We've recently discovered a potential issue with the D-shaped hub connection in our **Mechanical Dump Valves and Trunnions**. The tolerances applied to the newly designed hub-to-shaft (or hub/shaft) connections were too loose, allowing for greater play at this D-shaped connection than is ideal.

HUB-TO-SHAFT CONNECTION

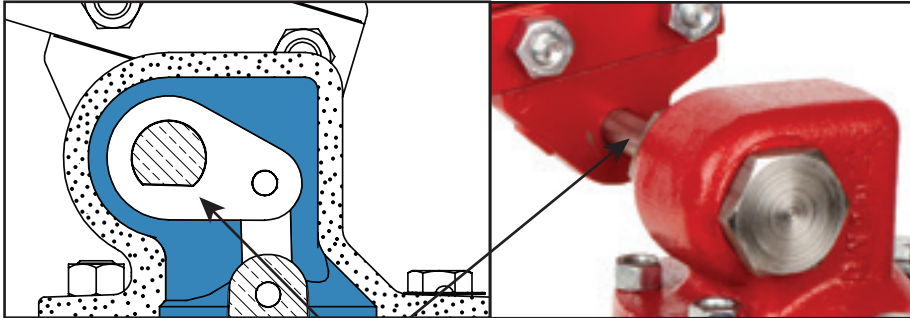
Specifically, as the float reaches its fully UP position, this might not be enough to fully open the valve, due to the amount of play in the D-shaft/hub connections. This is a potential performance issue, not a safety issue.

We have quickly corrected this issue by tightening the tolerances (making the shaft dimensions larger).

The solution for affected valves and trunnions is to replace the shafts with new shafts that have a larger dimension, as mentioned above.
